2013 OBD/GHG14, 6-Gallon DEF Header Suction Line Connection Broken by Ice Pressure

49-16

**Western Star
Service Bulletin**

Fig. 2, WEMA Six Gallon DEF Tank Header Assembly

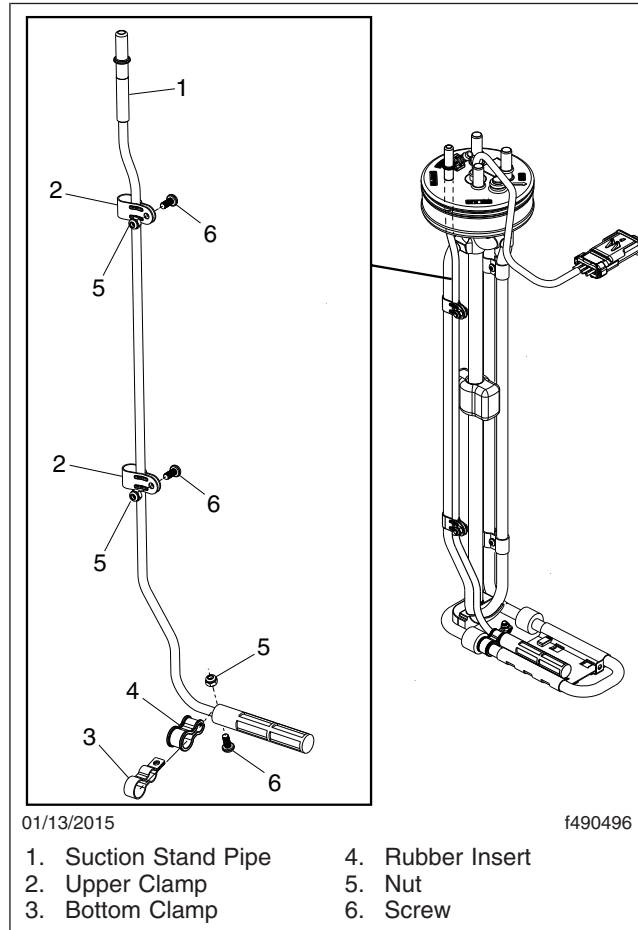
Replacing the suction stand pipe involves removing the header from the tank, disassembling the header and reassembling it with the new suction stand pipe that has smaller diameter and a larger fitting. With the larger fitting on the stand pipe, a different DEF line is required to connect to it.

9. Remove the header from the DEF tank.
 10. If desired, rinse the header unit with hot water before working on it.
 11. Replace the DEF suction stand pipe.
 - 11.1 Remove the clamps that attach the suction stand pipe to the coolant pipe. (These may be clamps with screws and nuts, springs wound around the pipes, or zip ties.)
 - 11.2 Remove the rubber insert from the bottom clamp if applicable.
- NOTE: It takes about 9 kg of pulling force to remove the suction stand pipe from the rubber head.
- 11.3 Slide the suction stand pipe out from the bottom of the rubber head.

- 11.4 Install the new suction stand pipe into the rubber head from the bottom. Make sure it is properly positioned.
- 11.5 Install the new bottom clamp with the rubber insert directly behind the filter.
- 11.6 Install the new clamps at the two upper locations as shown in [Fig. 2](#).
- 11.7 Tighten the clamp fasteners 25 to 29 lbf·in (280 to 360 N·cm).
- 11.8 Verify that the stand pipe sticks out of the top of the head enough to connect the DEF line fitting.
- 11.9 Verify that the DEF level float can travel freely for the entire length of the sensor tube.

12. Install the header unit in the tank and secure it with the band clamp.
13. If the DEF tank was removed, position the tank on the frame rail bracket, and install the two DEF tank mounting bolts and nuts. Tighten 128 lbf·ft (174 N·m).
14. Remove the DEF suction line and install the new one.
15. Connect the DEF lines.
16. Connect the coolant lines.
17. Install zip ties as needed to hold the chassis electrical harness to blue DEF lines on side of tank.
18. Remove the line clamps.
19. Connect the harness connector to the DEF sensor.
20. Connect the battery cables.
21. Start the engine and check for leaks. Repair as needed.
22. Put a dot of white paint on the connector to indicate the retrofit has been done.
